Terex Utilities**PRODUCT NOTICE****PN695****DATE:** 7/21/2021**REVISED:****TO:** Owners, Users, Dealers, and Installers**MODELS AFFECTED:** LT40**SUBJECT:** Positive Attachment Lanyard (PAL) Device Alarm**Issue:**

Figure 1. Clearance hole in cover

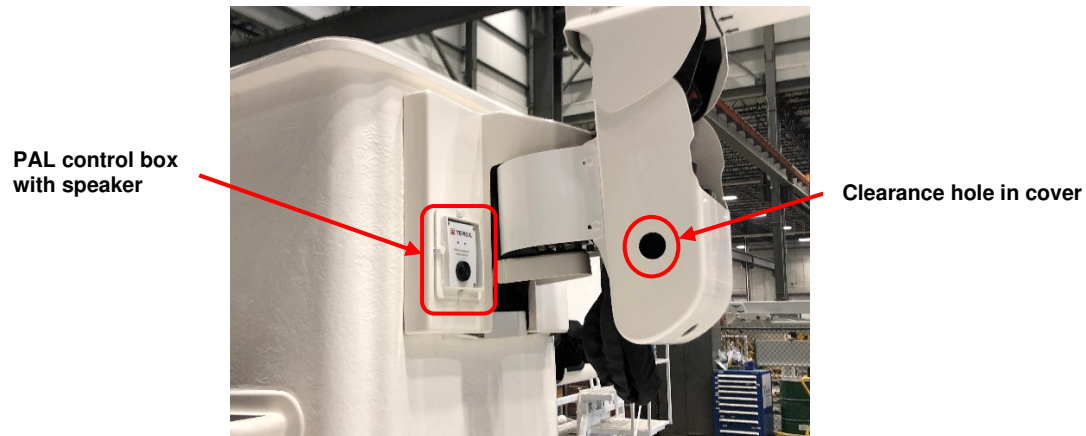
3. Inspect the unit to determine if it has a clearance hole in the rotator bracket cover for the PAL control box speaker as shown in Figure 1.

4. If the alarm indication is 1 beep every 10 seconds or there is not a clearance hole in the cover, see the continued use section for further instructions.
5. If the alarm indication is 6 successive beeps followed by a 5 second pause and then repeated, and there is a clearance hole in the cover; this bulletin does not apply. The unit can be used following all operator, maintenance, and inspection requirements as specified in the manuals.

Terex will provide Field Service Kit Z1630, parts and labor, at no cost to the customer for a period of one (1) year from the release date of this bulletin.
